Form 1 - Responsible Authority Report (Regulation 12)

Property Location:	Lots 7,10,12,30,50,53,101 Kiln Road and Lot 802 South West Highway, Byford
Development Description:	Factory Expansion and Ancillary Development
DAP Name:	Metro Outer Joint Development Assessment Panel
Applicant:	Austral Bricks
Owner:	Bristle Holdings Pty Ltd
Value of Development:	\$55,000,000
LG Reference:	PA19/1121
Responsible Authority:	Shire of Serpentine Jarrahdale
Authorising Officer:	Ashwin Nair - Manager Statutory Planning and Compliance
DAP File No:	DAP/19/01712
Report Due Date:	20 August 2020
Application Received Date:	29 November 2019
Application Process Days:	90 days
Attachment(s):	1. Application Details 2. Summary of submissions 3. Council Minutes (extract)

Figure 9: Sensitive Receptors

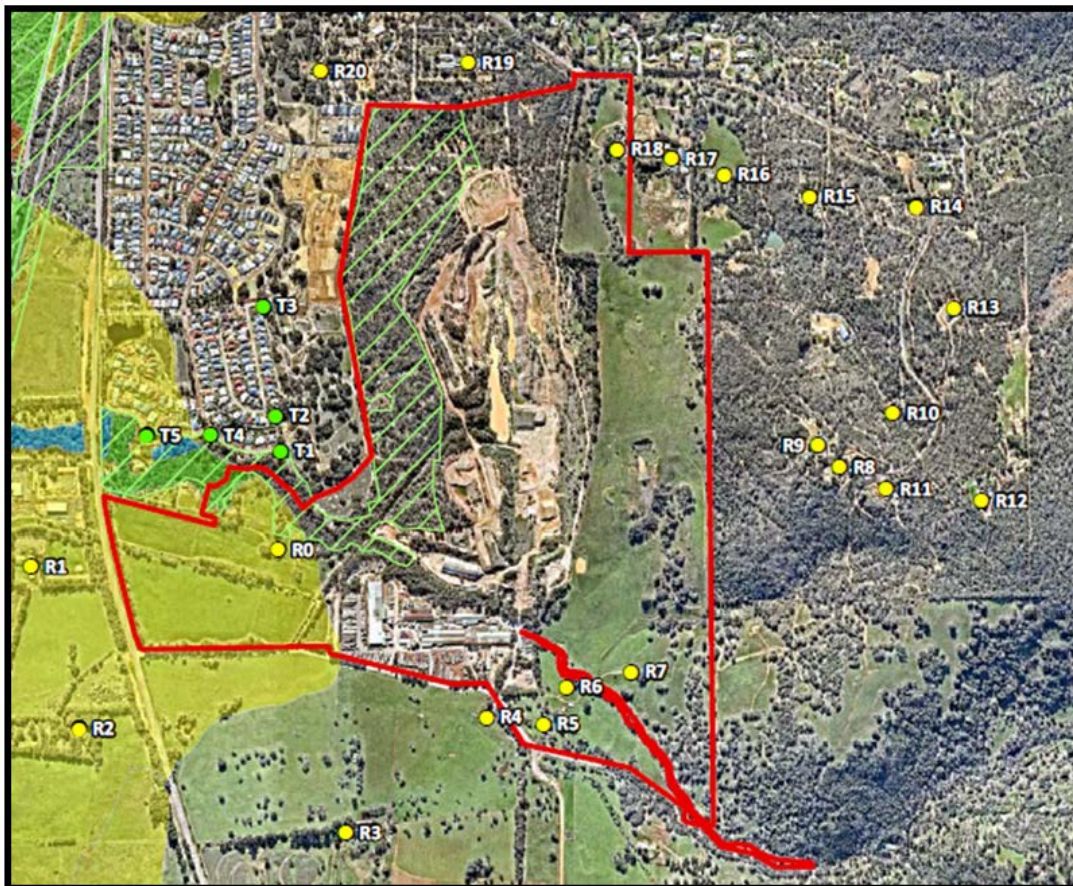
- the maximum predicted ground level concentrations for a 1-hour average occurs to the east of the brickworks on the edge of the scarp in an area with no identified receptors; and
- The highest predicted ground level concentrations at any receptor occur at Receptors R0 and R15, as depicted on the plan below. Receptor R0 is to the west of the brickworks and is the closest receptor to the proposed emission sources (approximately 250m). Receptor R15 is northeast of the brickworks at the foot of the scarp (refer to Figure below).

Officers note that averaged data ranges are used in terms of depicting what may be the air emission amenity outcome. While Officers note that the table demonstrates compliance with air quality guideline value, expressed as a percentage, the use of an average of values may not show what could be the maximum impact, nor the likely magnitude (number) of such impact events. Also, in noting the reliance on meteorological data from a site distant from the Kiln Road location, and different in its weather conditions in terms of wind, creates further uncertainty as to this amenity issue.
